Historic District Self-Guided Tours
Example Materials for Third Lake Ridge
August 20, 2019

At its July 30, 2019 meeting, the LORC requested that staff assemble a sample of materials to facilitate members taking self-guided tours of the local historic districts. Attached is a sample of materials for the Third Lake Ridge district for review/discussion at the August 20 meeting. The examples shown are clustered in the 700-800 blocks of Williamson and Jennifer Streets.

Project Name/Address: 743 Williamson
Application Type: Certificate of Appropriateness for exterior alteration in historic district
Legistar File ID # [42801](#)
Prepared By: Amy L. Scanlon, Preservation Planner, Planning Division
Date Prepared: June 1, 2016

Capital Times Historic Photo from 1947

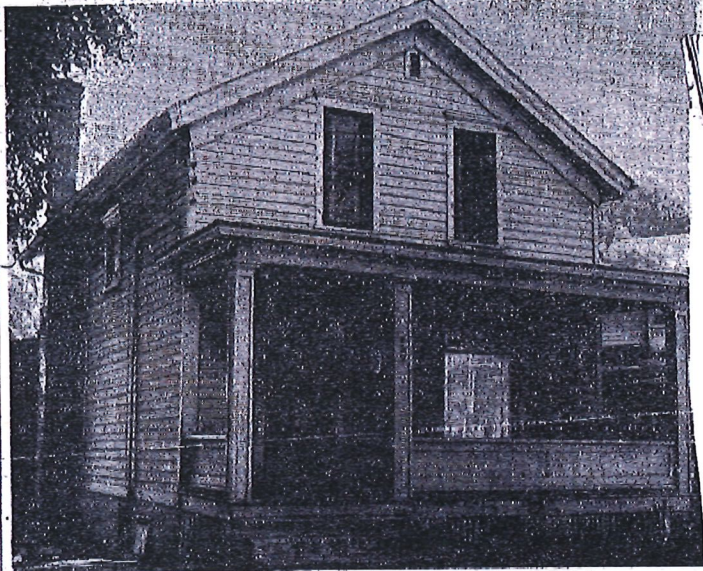
The applicant has not submitted any plans for the new front porch; however they have submitted several photographs of porches that they would like emulate. Staff has enclosed a historic photo of the house with an earlier more appropriate porch. Staff recommends that this photo be used as a basis for the new porch design, noting the need for a code-compliant railing.

Noting both the recent and historic photo, staff recommends the re-installation of the original window configuration, and would not support the approval of the sliding glass doors.
